COUNCIL ASSESSMENT REPORT

Panel Reference	2019SNH019 DA
DA Number	LDA2019/0073
LGA	City of Ryde
Proposed Development	Demolition of existing public car park to construct a multi-level public car park to accommodate 146 cars spaces. The application is referred to the Sydney North Planning Panel pursuant to the <i>Environmental Planning and Assessment Act 1979</i> for determination as the capital investment value exceeds \$5 million for a Council related development
Street Address	53-71 Rowe Street, Eastwood (Lot 1, DP 947742)
Applicant/Owner	City of Ryde Council
Date of DA lodgement	28 February 2019
Number of Submissions	Three (3)
Recommendation	Approve
Regional Development Criteria Schedule 7 of the SEPP (State and Regional Development) 2011	<p>Council related development over \$5 million</p> <ul style="list-style-type: none"> • Council for the area in which the development is to be carried out is the applicant for development consent • The council is the owner of any land on which the development is to be carried out • The development is to be carried out by the council

This report considers a development application (DA) under Section 4.12 of the *Environmental Planning and Asse

Figure 6: Ground floor plan of proposal (Source: Architectural Plans)

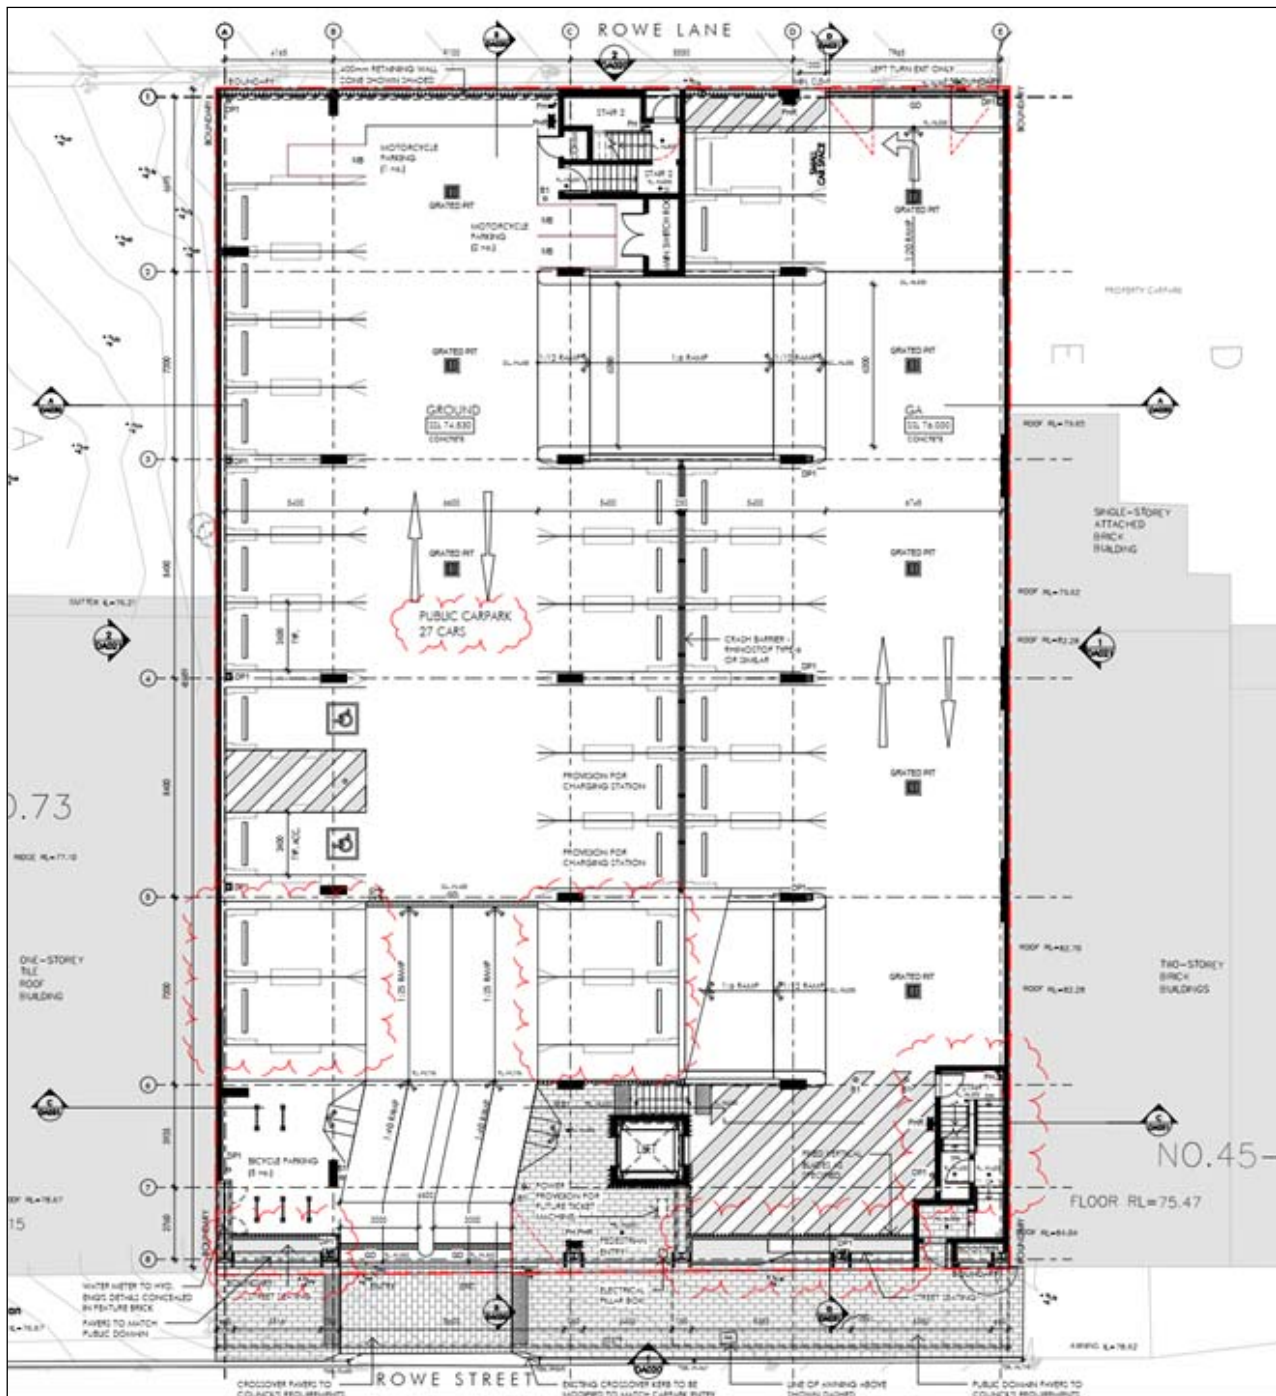
| | <ul style="list-style-type: none"> The plans indicate the potential for 'future' parking ticket machine which would entail installation of boom gates. The proposed design could result in queueing onto the footpath. Lesser queue lengths may be required for a vehicle number plate recognition system. A queue analysis is advised should the proposed 'no controlled entry' change in the future. The exit configuration to Rowe Lane is satisfactory, however an increase to the exit lane width to 4m would be beneficial and is conditioned. All parking aisle dimension, grades and space widths are considered compliant with relevant standards. Subject to recommended conditions, the proposal is acceptable. <p><i>Comment: The recommended conditions of consent have been included in the draft consent.(See condition numbers 13 to 15, 33, 42 to 45, 79, 94, 100).</i></p> |

Figure 10: Southern elevation with 15.5m height limit outlined in dashed red and non compliances in red

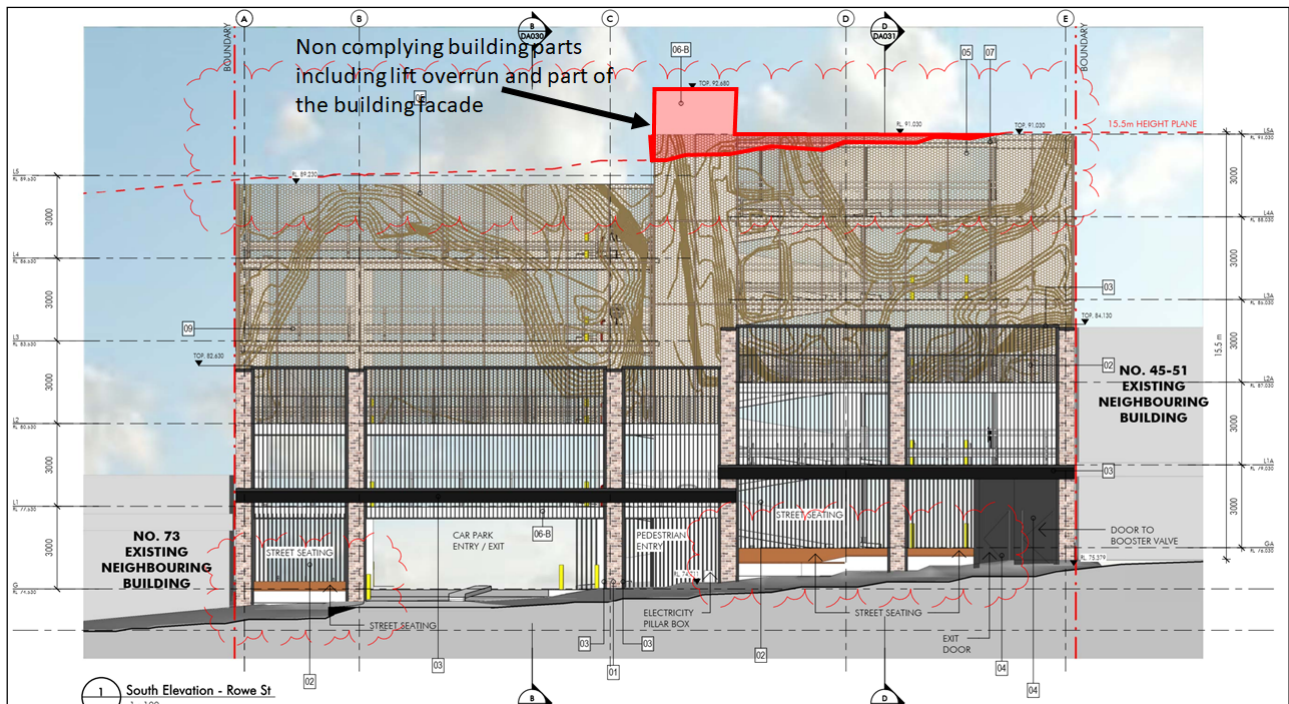
The proposal exceeds the height standard across a number of locations including:

Comment – It is accepted that the majority of the proposed building complies with the height limit. As discussed, the non compliances relate to the lift overrun and parts of the southern perforated aluminium mesh screen façade. The overall noncompliance is considered minor and acceptable.

Comment – The non complying height is limited to the centre of the southern façade. The minor noncompliance would not result in any unacceptable privacy impacts to adjoining properties.

In summary, the applicant has adequately addressed the matters under clause 4.6(3)(b) to satisfactorily justify breaching the height standard on environmental planning grounds. It is considered in this instance, the minor variation to the development standard is supported.
